HDC-2022-00016**Address: 23 N. 12th Street****Applicant: Pedro Ditsen, Contractor on behalf of Owner Hypolite Johnson****HARB Meeting Date: June 6, 2022****Building Description:**

HDC-2022-00026**Address: 319 N. 8th Street****Applicant: Bachman Roofing, Contractor****HARB Meeting Date: June 6, 2022****Building Description:**

HDC-2022-00024**Address: 428 N. 6th Street****Applicant: Allentown Redevelopment Authority, Owner****HARB Meeting Date: June 6, 2022****Building Description:**

HDC-2022-00022**Address: 506 N. 5th Street****Applicant: Juan Salce Murillo, Owner, and Kimberly Smith, Contractor****HARB Meeting Date: June 6, 2022****Building Description:**

Elevation on N 6th Street (Applicant)**Elevation (Applicant)****Applicable Guidelines:****5.1 New Buildings****HEIGHT GUIDELINES**

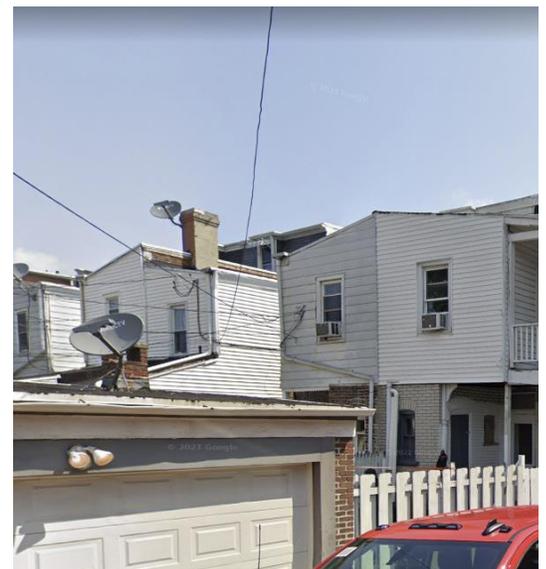
Appropriateness is evaluated by the factors of height, massing, size and scale, setback, proportion, materials, detailing, and fenestration. The proposed new construction appears to comply with the Guidelines. Observations of the surrounding context indicated that the proposed height, massing, size and scale, and setback are consistent with the adjacent buildings especially on this side of the block. The proportions and facade rhythms are also consistent with the surrounding buildings. Mansard roofs, gable dormers, articulated facades, and ornate wood trim are present across this side of the 6th street block.

GL requested more information on the rear façade and does it face onto a street that would be visible. Applicant clarified the front and rear facades will be the same. The rear will be visible from the alley. DH asked where parking will be and Applicant clarified it will be at the rear.

AJ stated objection to the design choice as faux historicism but the design is compliant with the Guidelines.

AJ raised concerns of the design being compatible with the surrounding contextual massing. The applicant addressed this concern with the clarifying the topography of the streetscape as it steps up and the building design addresses the neighboring massing. Applicant clarified that elevation of basement and building height will match height of surrounding structures.

AE asked a question regarding representation of the structural supports in the form of lintels and design inside the pediment.

1. New construction of a 2 ½ story, multi-unit apartment building on an existing vacant lot. Height, massing, size and scale, setback, proportions, and overall design shall be as submitted. Changes or revisions to these factors or similar design elements shall be submitted to Staff and HARB for consideration as an amendment to this Certificate of Appropriateness.
2. Detailed choices for exterior materials shall be submitted to HARB for review and approval.
